Well Name: PATON FEDERAL	Well Location: T18S / R27E / SEC 6 / SESW /	County or Parish/State: EDDY / NM
Well Number: 2	Type of Well: INJECTION - ENHANCED RECOVERY	Allottee or Tribe Name:
Lease Number: NMLC060894	Unit or CA Name:	Unit or CA Number:
US Well Number: 300150080000S1	Well Status: Water Injection Well	Operator: REDWOOD OPERATING LLC

### Notice of Intent

Type of Action: Plug and Abandonment

# Plug Abandonment NOI Proposed

Redwood Operating, LLC		PROPOSED	
Author:	Abby @ BCM	Well No.	#2
Well Name	Paton Federal	API #:	30-015-00800
Field/Pool	Red Lake	Location:	Sec 6, T18S, R27E
County	Eddy		330 FSL & 2290 FWL
State	NM	GL:	3350
Spud Date	9/9/1957

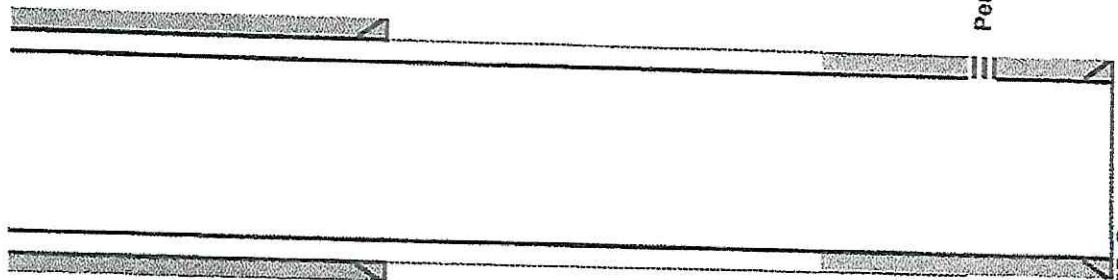
1. Set 5 1/2" CIBP @ 1640'. Circ hole w/ MLF. Pressure test csg. Spot ~~25~~ sx cmt @ 1640-1440'. 1640' to 1096' 55 sx
2. Perf & Sqz 50 sx cmt @ 967-767'. WOC & Tag (8 5/8" Shoe & GRBG)
3. Perf & Sqz 50 sx cmt @ 200' to surface. 400' to surface. 100 sx
4. Cut off well head, verify cmt @ surface, weld on Dry Hole Marker.

Plug Type	Top	Bottom	Length	Tag	Sacks	Notes
Surface Plug	0.00	400.00	400.00	Tag/Verify		
				If solid base no need to Tag (CIBP present and/or Mechanical Integrity Test), If Perf & Sqz then Tag, Leak Test all CIBP if no Open Perforatio		
Fresh Water @ 350	296.50	400.00	103.50	100.00	Perf at 400'. Squeeze from 400' to surface.	
					Perf at 967'. Squeeze from 967' to 767'. WOC and Tag.	
Shoe Plug	857.83	967.00	109.17	Tag/Verify	50.00	
San Andres @ 1158	1096.42	1208.00	111.58	If solid		
				If solid base no need to Tag (CIBP present and/or Mechanical Integrity Test), If Perf & Sqz then Tag, Leak Test all CIBP if no Open Perforatio		
CIBP Plug	1605.00	1640.00	35.00	55.00	Set CIBP at 1640'. Leak Test CIBP. Spot from 1640' to 1096'.	
Perforations Plug (If No CIBP)	1640.00	1776.00	136.00	Tag/Verify		Not Necessary
Shoe Plug	1697.35	1815.00	117.65	Tag/Verify		Not Necessary

3. Perf & Sqz 50 sx cmt @ 290' to surface.  
100 SX 400'

1. Set 5 1/2" CIBP @ 1640'. Circ hole w/ MLF. Pressure test csg. Spot 20 sx cmt @ 1640-1440'.  
1096'

55 SY
